**GROWTH MANAGEMENT DEPARTMENT STAFF REPORT**  
**SOUTH ANASTASIA OVERLAY DISTRICT**  
**December 15, 2022 Public Meeting**  
**SADRB 2022-03 Biera Mar Mixed-Use Development**

**Summary of Request:** The applicant requests design approval of a 2-story mixed use building with 2,705 square feet of commercial space and two (2) 1,500 square foot residential units. This request is a companion application to NZVAR 2022-11.

# EDMONDS TRUST - CONCEPT PLAN

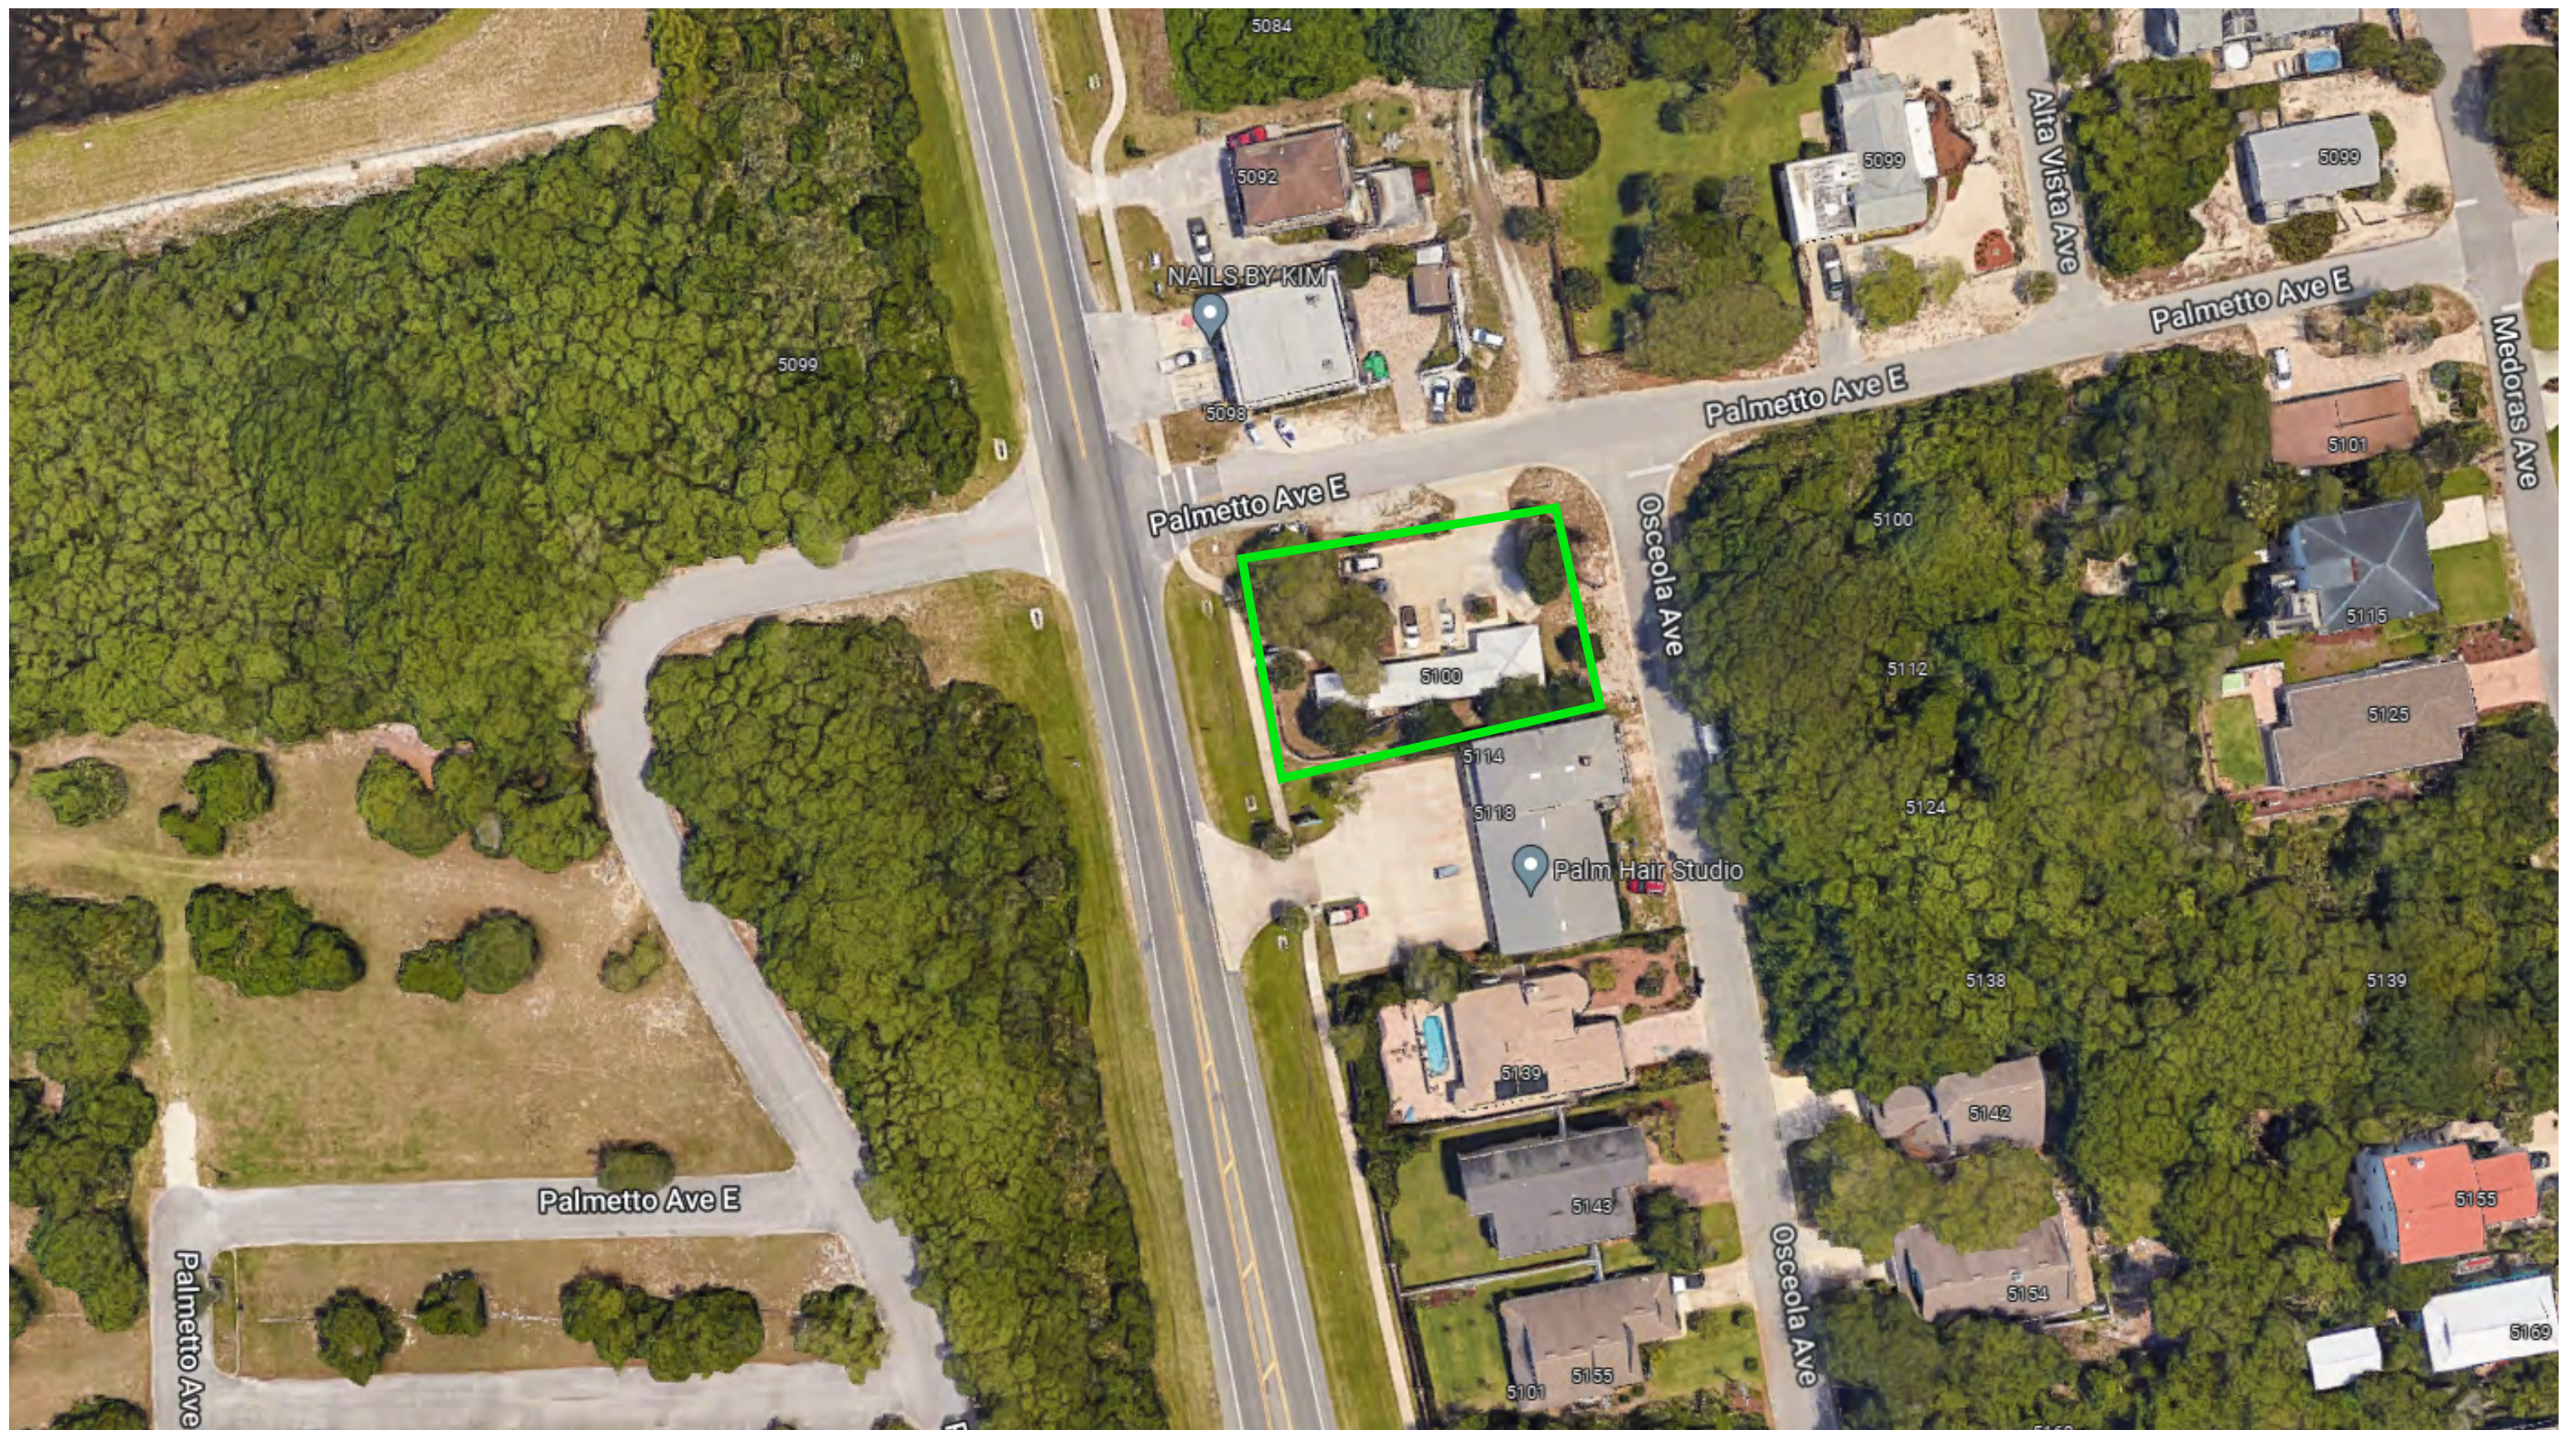
This project meets the development standards of LDC 3.07.04 with a proposed impervious surface ratio (ISR) of 62.5%, which is less than the allowed maximum 65%. Additionally, the gross floor area (GFA) for commercial uses is limited at 10,000 square feet per acre. The site is approximately 0.26 acres, which permits the 2,600 square feet of commercial uses as designed.

The placement of the proposed building as shown on the concept plan meets the minimum yard and buffer requirements as set forth in LDC Section 3.07.05 and 3.07.06, except for the area between structures at the southern property boundary. The applicant is seeking a Variance to reduce the minimum separation between the new building and the existing mixed-use building from 20 feet to 10 feet and to allow the new building to be constructed 5 feet from the southern property boundary in lieu of 10 feet (NZVAR 2022-11). Staff notes that since the subject property is a corner through lot, two of the frontages are allowed a reduction of up to 20% per LDC Section 6.01.03.E4.
